Newmar Corporation

RSB 559
Nov 6, 2020

NHTSA #20V 594

RECALL SERVICE BULLETIN

Work Instructions for Front Jack Inspection and Repair

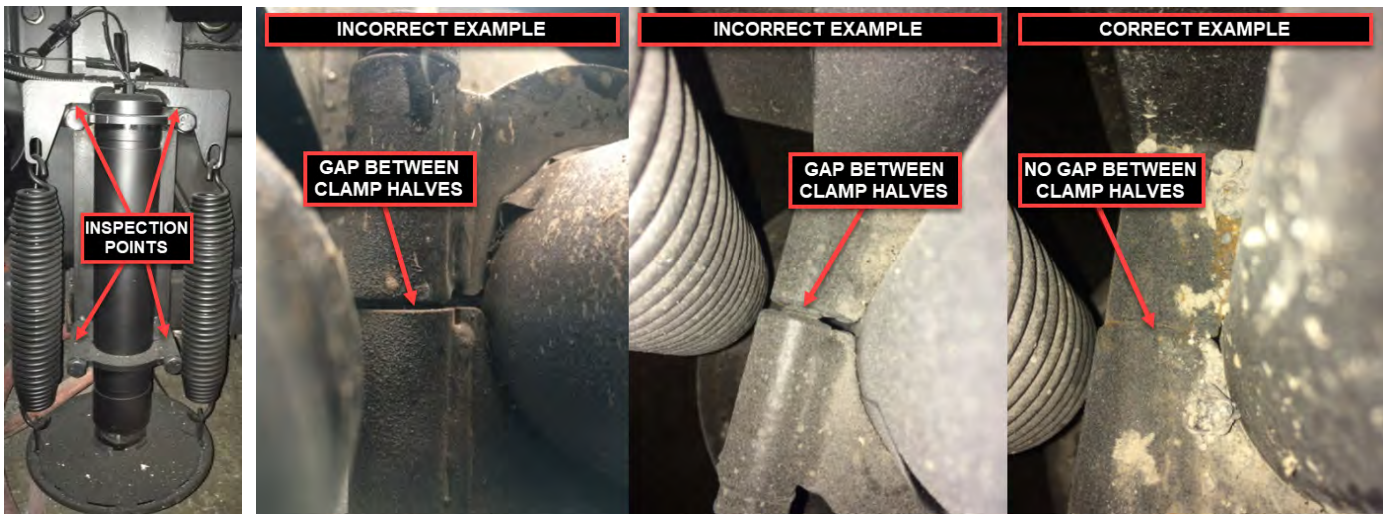
Inspect the front jacks to determine if any gaps are present at the clamps, which hold the jacks in place. There are four clamp halves on each jack, as well as bolts that go through them creating an inspection point. This is where the clamp halves come together at both sides of the jack: one near the top and near the bottom of the cylinder. A total of eight joints must be inspected (four on the passenger side and four on the driver side).

If one or more clamped joints are gapped, both jacks will need to be removed and inspected, then have the clamp placement corrected.

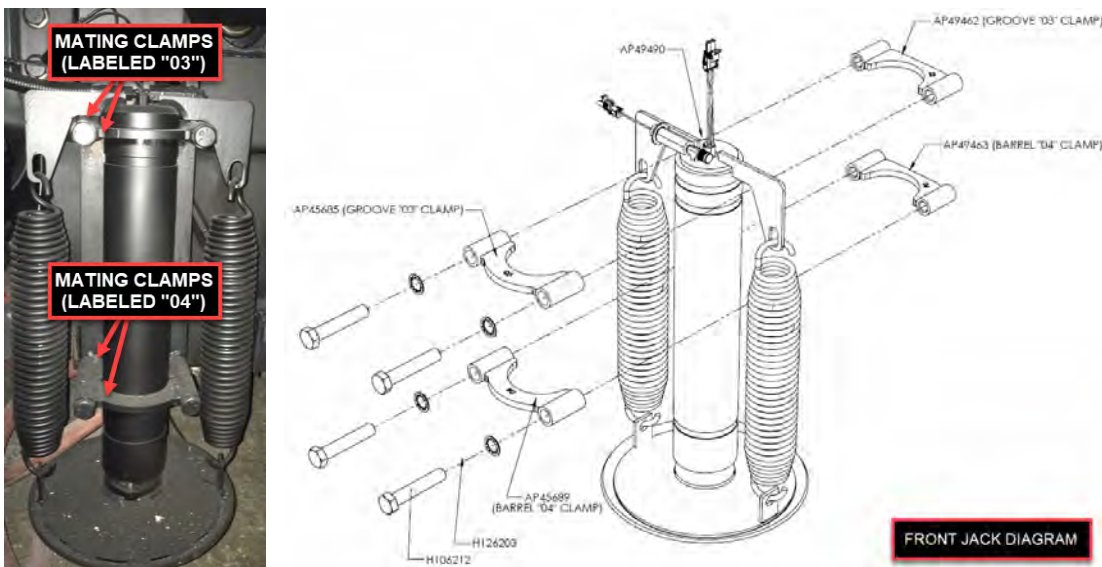
Place the clamps so you know where you took them off, and determine if the clamp was intended to be in the groove of the cylinder or on the barrel of the cylinder.

- Clamps labeled "03" are intended to be used in the groove of the cylinder.
- Clamps labeled "04" are intended to be used on the barrel of the cylinder.

The clamp halves must match for the intended position. Both upper clamps that fit in the groove must be 03 clamps, and both lower clamps that fit around the jack without the groove must both be 04 clamps.

If the welded half of the clamp is correct, then just the outer half brackets can be reoriented (mated) and reassembled.

The clamp half that is welded to the bracket could be wrong. If so, it will need to be cut off the bracket and a new, correct clamp welded back in its place. It is suggested to use a plasma cutter (if available) and grind smooth; otherwise, use another quality cutting device, and grind smooth in preparation of welding on new bracket(s).
